SPENDING ON GUMWOOD/REDFIELD PROJECT IN CURRENT FORMAT SHOULD STOP

FEASIBILITY STUDY

Gumwood Road & Redfield Street

**Milton Township,
Cass County, Michigan**

FIGURE 8

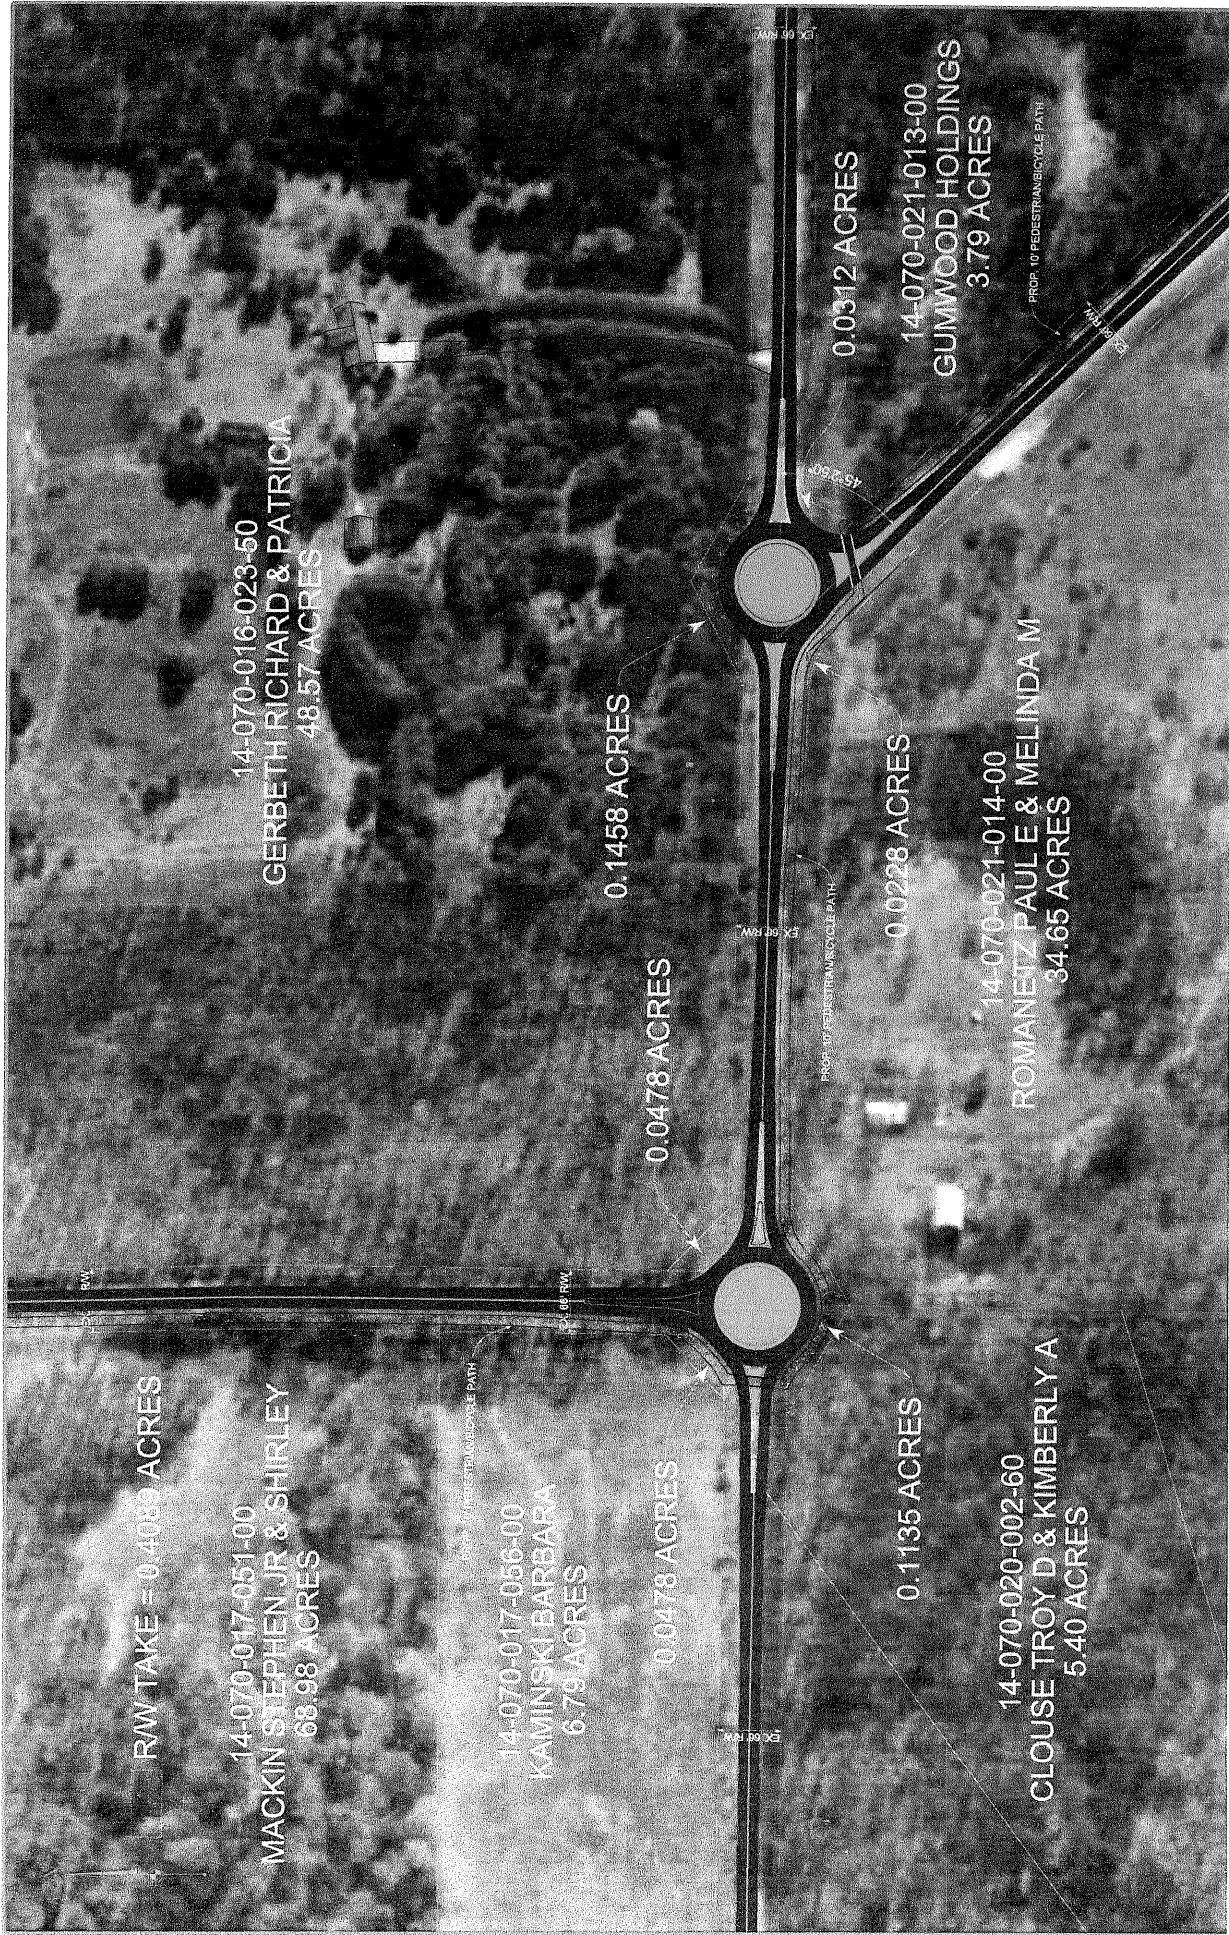
(4) the two roundabout involves far less taking of property for right of way (figure 8 - .2 acres vs. Figure 7 – 7.8 acres)

Spending decisions by government agencies should be based on prudent selection of the most cost-effective alternative: that solution is two roundabouts. It is unwise, uncertain, and wasteful to spend money for single roundabout.
